**DEPARTMENT OF COMMUNITY DEVELOPMENT
Design Review Committee Agenda**

To: Design Review Committee
From: Jo Ann Hunter, Principal Planner
Date: September 26, 2016
Subject: COA-2016-00012 Page Audi

COA-2016-00012

Project: Audi Car Dealership (landscaping, site design, and lighting only)

WEST BROAD AUDI
 12592 BROAD STREET ROAD
OVERALL LANDSCAPE PLAN
 DISTRICT 4
 GOCHLAND COUNTY, VIRGINIA

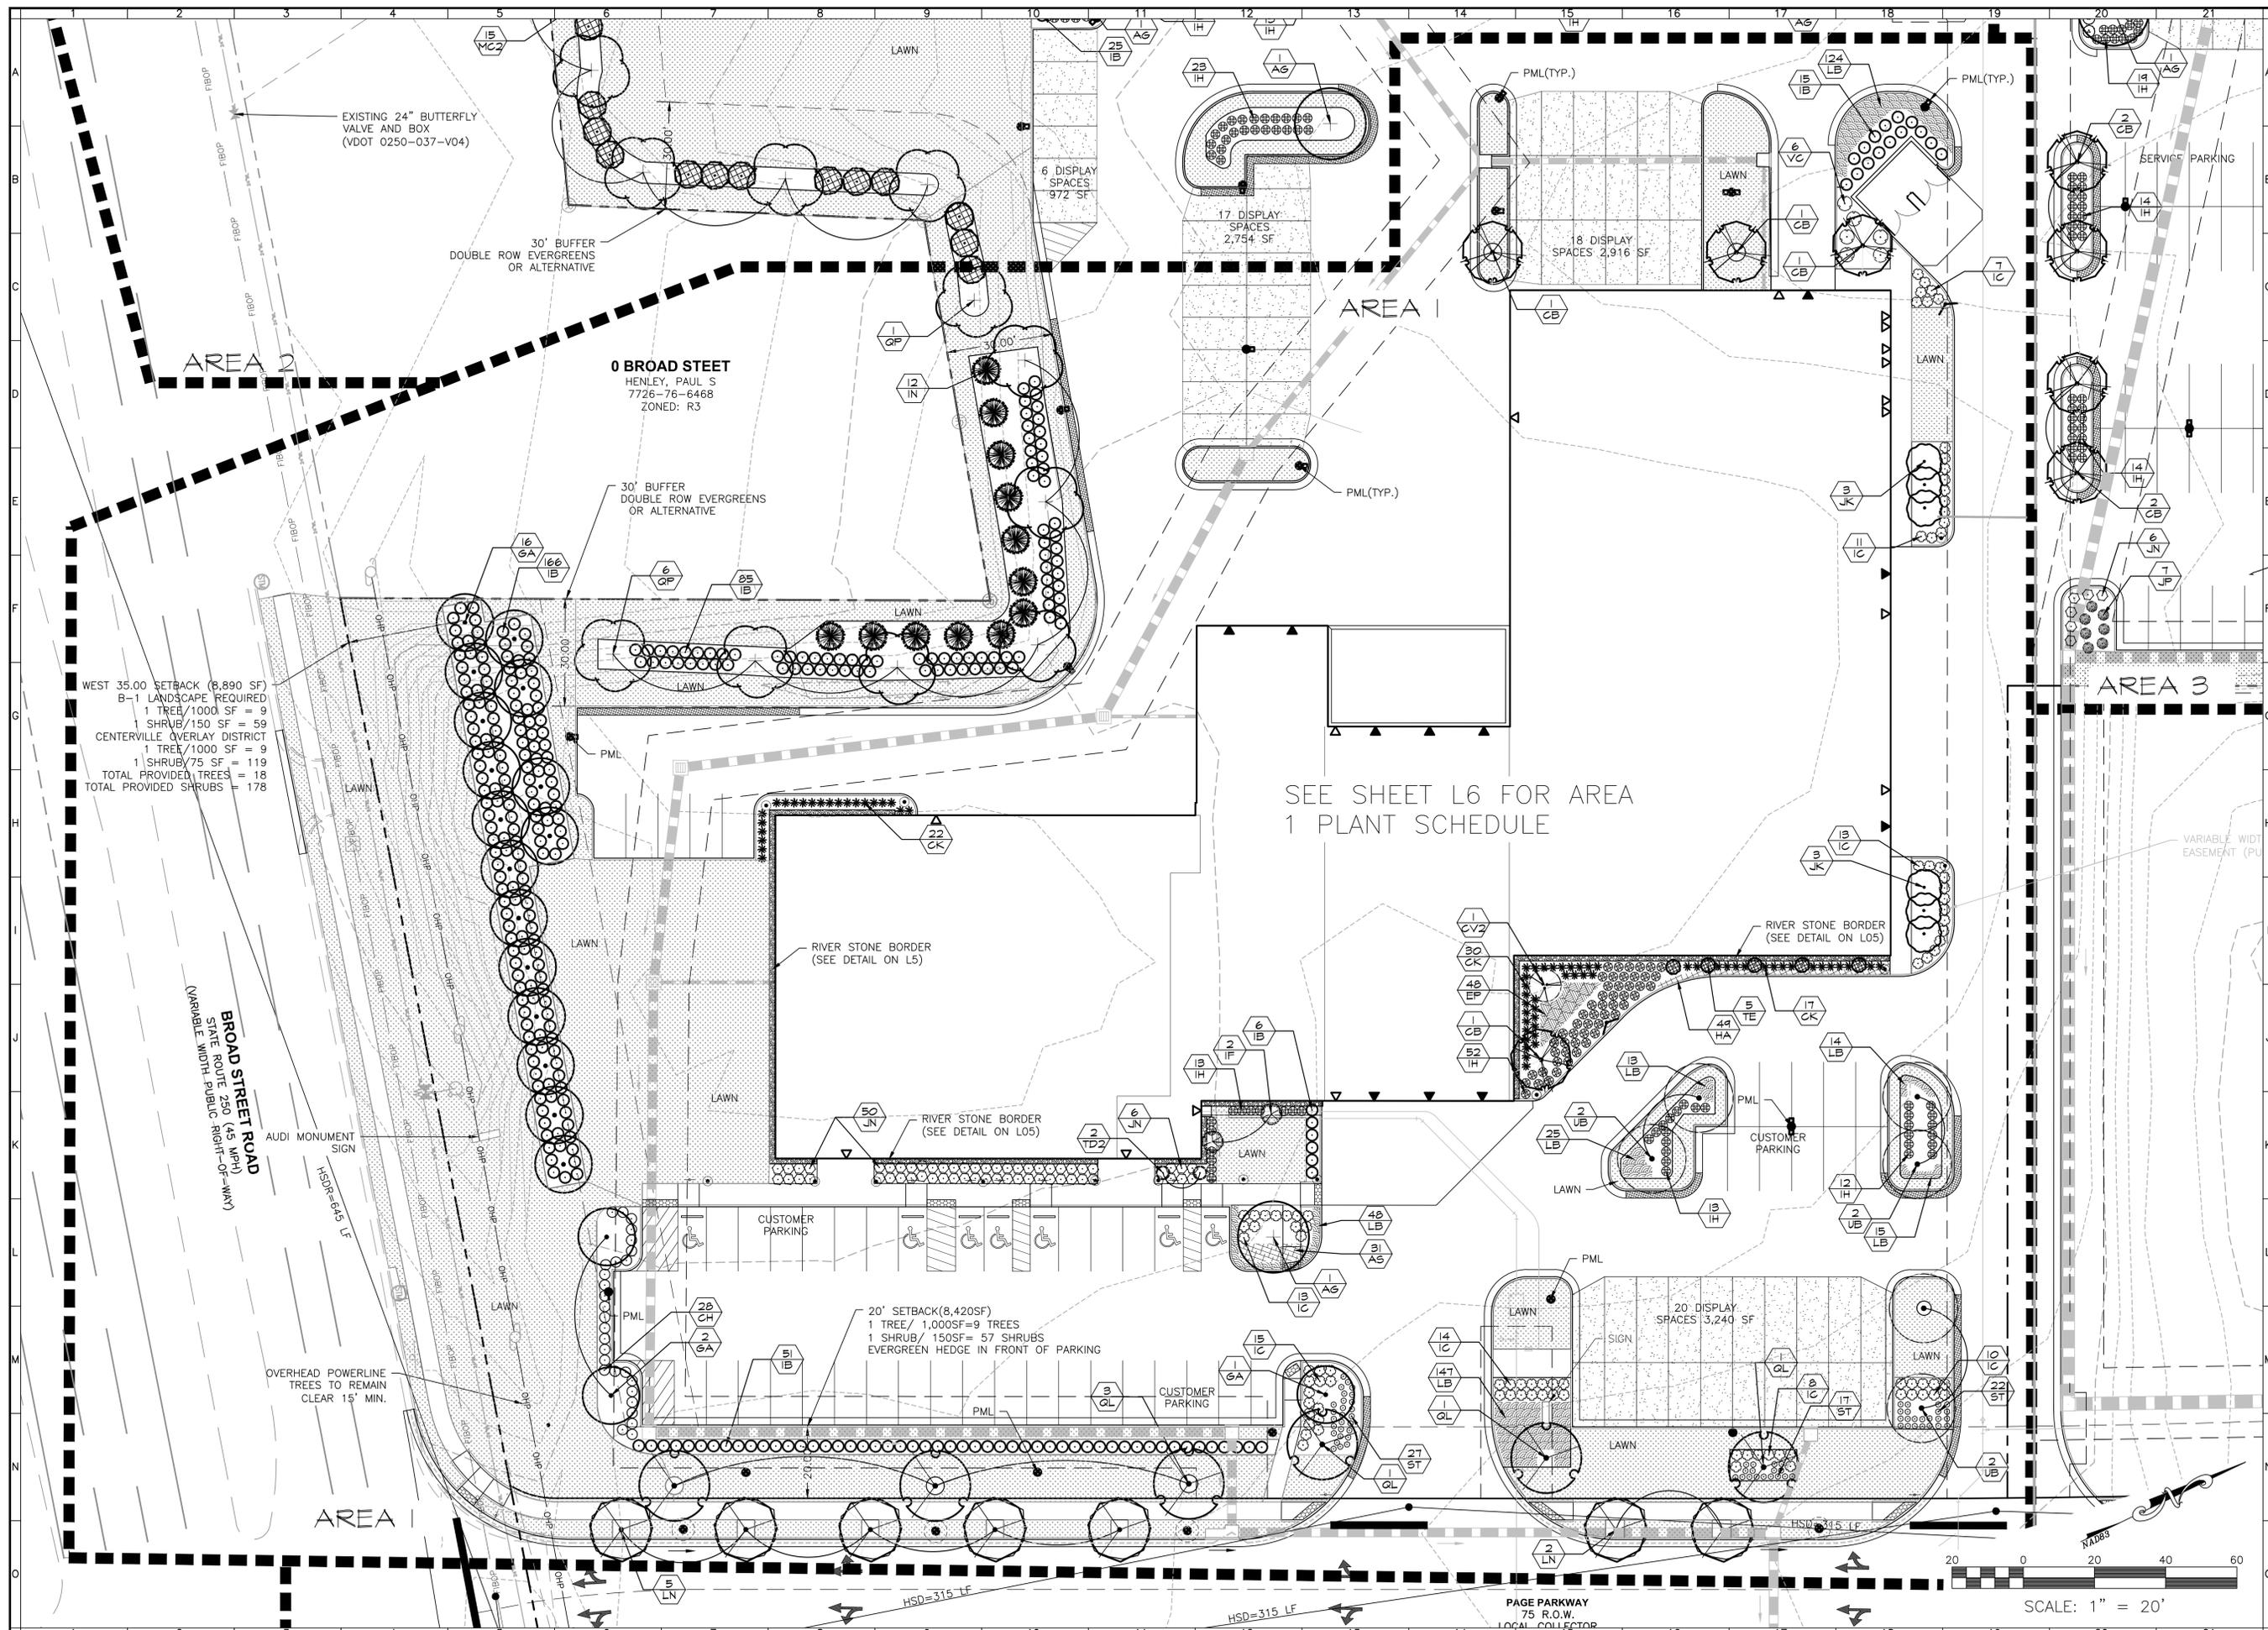
- Two trees along Page Parkway are on top of pipe structures and need to be relocated
- Landscaping along Three Chopt by the rear parking area are within a utility easement

- The landscaping that is in the public right-of-way will need to meet VDOT landscaping/planting standards
- A 3' evergreen hedge needed around all parking areas – staff would recommend the addition of this type of hedge to 4 areas:

- the 2nd parking area on Page Parkway,
 - the parking area that backs up to R-3 piece,
 - and around the north and west sides of the rear parking area
- Previous conceptual plans included street trees in the Broad Street median – the applicant should clarify if they will be doing these plantings

- Staff would recommend an evergreen hedge adjacent to car wash boundary – Overlay district prohibits bay doors from facing Broad St. While this is set back from Broad and is a side yard, staff would recommend the evergreen screening to meet the intent of the Ordinance

- Previous plans had pavers in front of building and near service areas – the applicant should clarify if this is included

The submitted landscape plans do not include the living wall and the applicant is requesting approval for an alternate landscape plan. In lieu of the living wall, the applicant has submitted a heavily landscaped area in front of the wall that includes Arborvitaes, Japanese Hollies, and grasses.

1. Improvements shall be in substantial conformance with the Landscape Plan submitted by Balzer and Associates dated 9/14/16 with revisions to the landscaping and lighting plan as discussed in this staff report.
2. Sign Package will be reviewed with a subsequent administrative Certificate of Approval application; however, sign base shall match the natural stone of the building.
